ADDENDUM NO. 2

MLK ELEMENTARY SCHOOL WELLNESS CENTER BAKERSFIELD CITY SCHOOL DISTRICT

Project No.: 5527 DSA File No. 15-6 DSA App No. 03-122605 December 19, 2024

INTERIOR ELEVATIONS

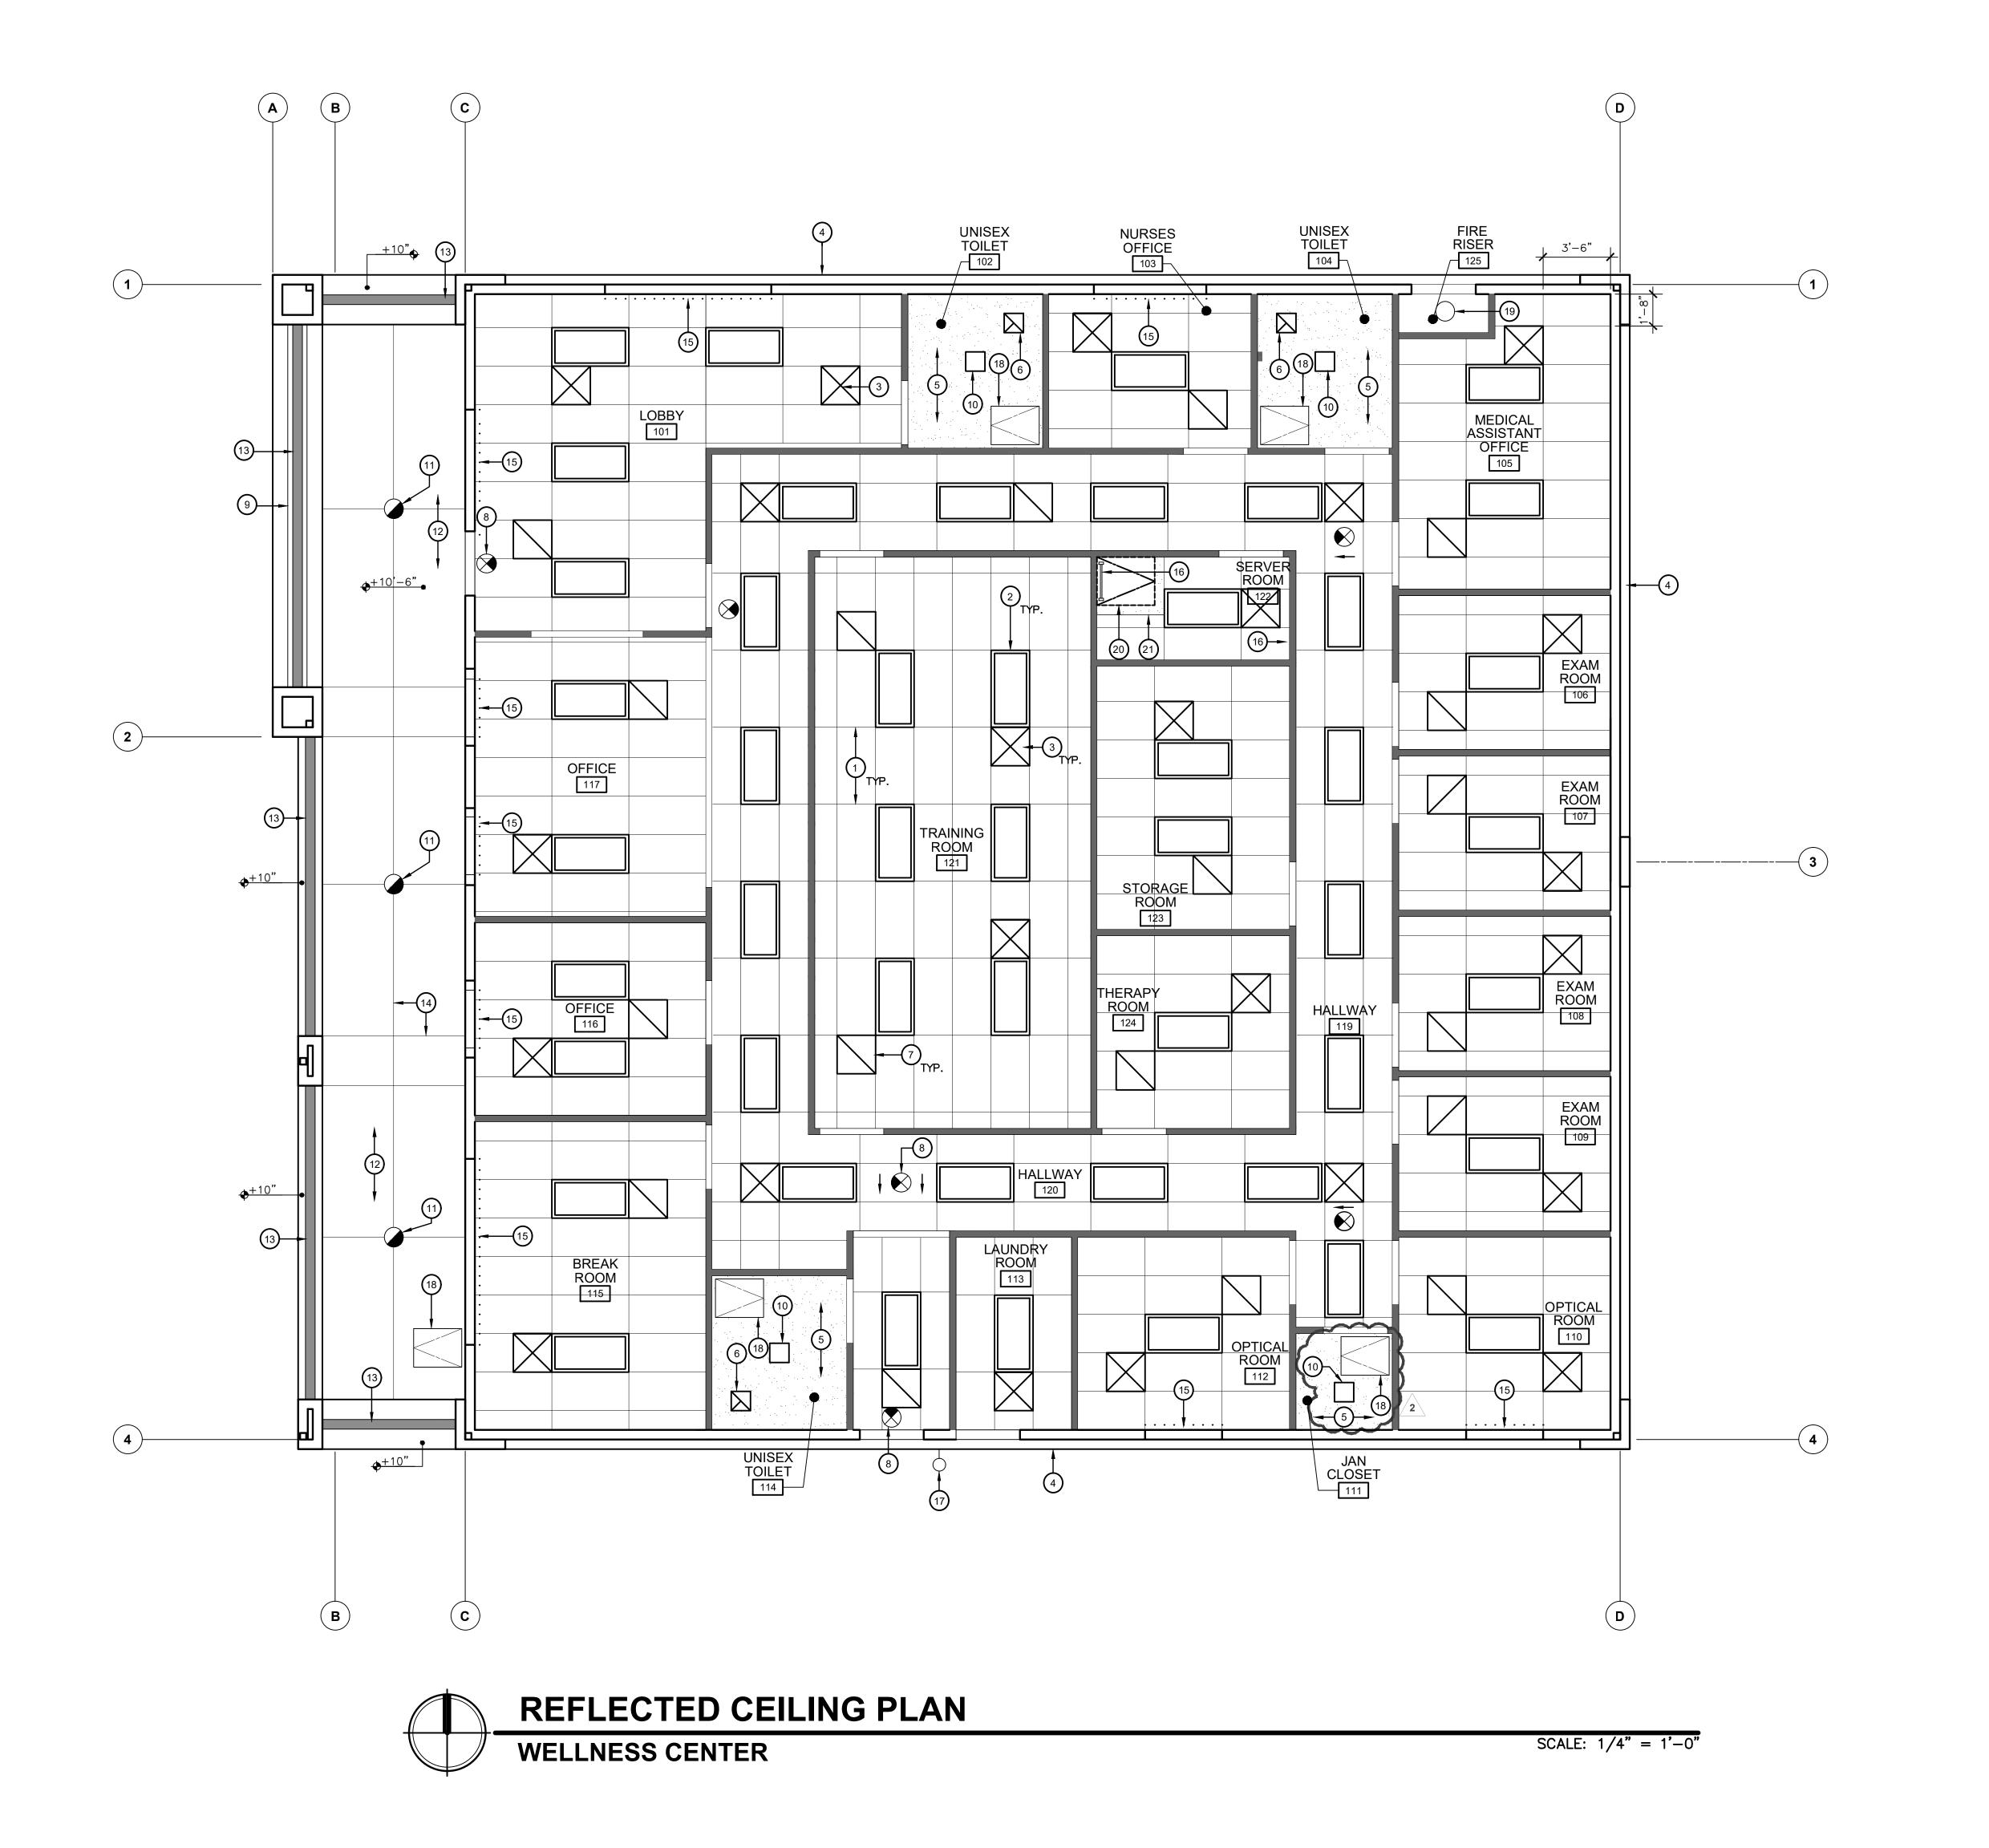
- 6. Delete elevations office room 116.
- **2-17 DRAWING, SHEET A5.11 INTERIOR ELEVATIONS:** Note the following changes (see A5.11 addendum 2 drawing):

- 1. Delete TVs from training room 121.
 - 2. Electrical server room 122.
 - i. Add elevations B and C
 - ii. Modify elevation A.
 - 3. Elevation "B" therapy room 124

- i. Add TV. See keynote 7.
- **2-18 DRAWING, SHEET A6.10 REFLECTED CEILING PLAN:** Note the following changes (See A6.10 addendum 2 drawing):
 - 1. Add ceiling access door to room 111.

S4.01

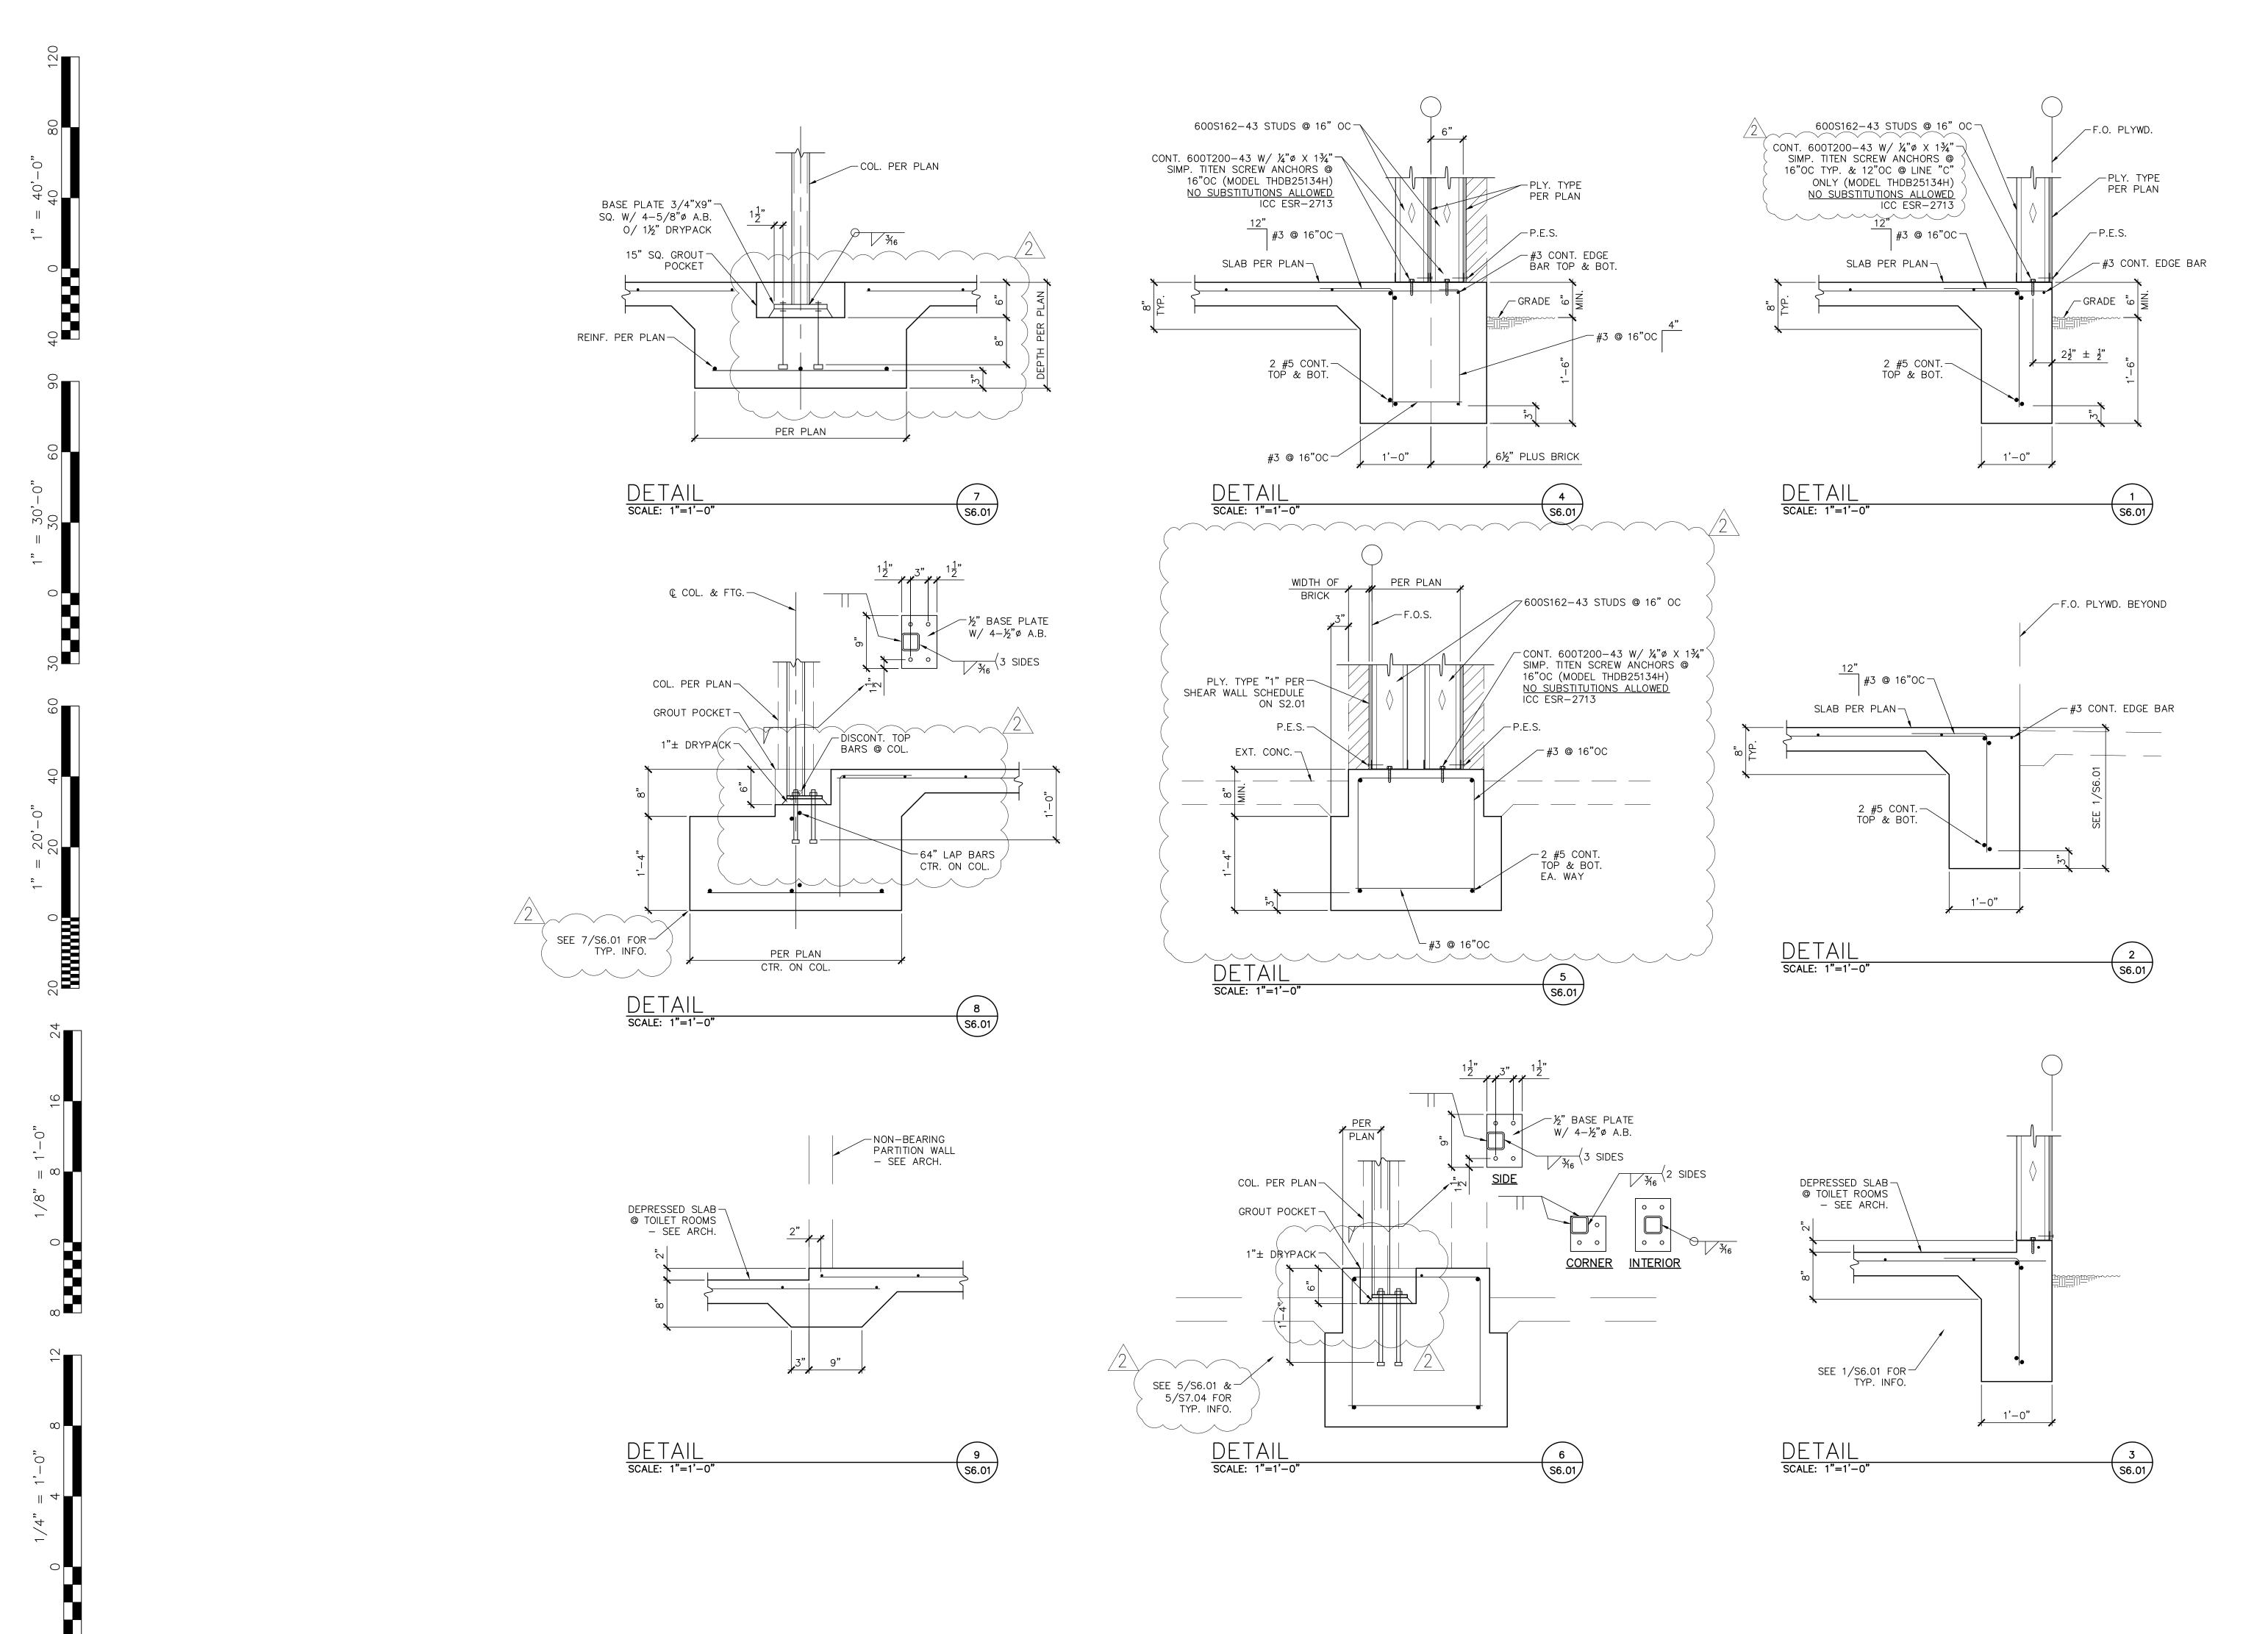
- 1. Add attic access door framing in janitor's room.
- **2-23 DRAWING, SHEET S4.01 ROOF FRAMING PLAN:** Note the following changes (See S4.01 addendum 2 drawing):

- 1. Dimensions for columns and pilaster have been changed.
 - 2. Location of mechanical units has changed.
- **2-24 DRAWING, SHEET S6.01 FOUNDATION DETAILS:** Note the following changes (See S6.01 addendum 2 drawings):
